SUBJECT: <b>POWER STEERING OIL FEED TUBE — SAFETY RECALL CAMPAIGN</b>		No: <b>SR-01-009</b>	
		DATE: <b>November, 2001</b>	
		MODEL: <b>2000 Eclipse &amp; Galant</b>	
CIRCULATE TO:	<input type="checkbox"/> GENERAL MANAGER	<input checked="" type="checkbox"/> PARTS MANAGER	<input checked="" type="checkbox"/> TECHNICIAN
<input checked="" type="checkbox"/> SERVICE ADVISOR	<input checked="" type="checkbox"/> SERVICE MANAGER	<input checked="" type="checkbox"/> WARRANTY PROCESSOR	<input type="checkbox"/> SALES MANAGER

Mitsubishi Motor Sales of America, Inc. (MMSA) is voluntarily recalling certain, affected 2000 model year Eclipse and Galant vehicles equipped with the 3.0L V6 engine, to replace the oil feed tube on the power steering rack assembly. Under specific operating conditions, the power steering oil feed tube may come in contact with the exhaust manifold mounted heat shield, causing a hole to be worn in this tube, thus allowing power steering fluid leakage. Leaking power steering fluid will gradually result in a loss of steering assist, and possibly smoke and/or fire.

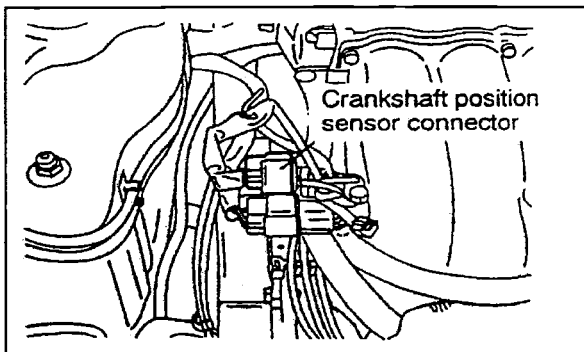
7. Using the torque wrench, tighten **both** flare nuts on the new oil feed tube to 13 Nm (113 in-lbs).

9. Complete the following INSPECTIONS:
  - a. Make sure there is at least 25 mm clearance between the exhaust manifold mounted heat shield and the new power steering oil feed tube.
  - b. Fill the power steering fluid reservoir.
  - c. Lower the vehicle, start the engine, and turn the steering wheel to full left and right lock, checking for any abnormal noise or sticking.
  - d. Check the newly installed tube for oil leaks.
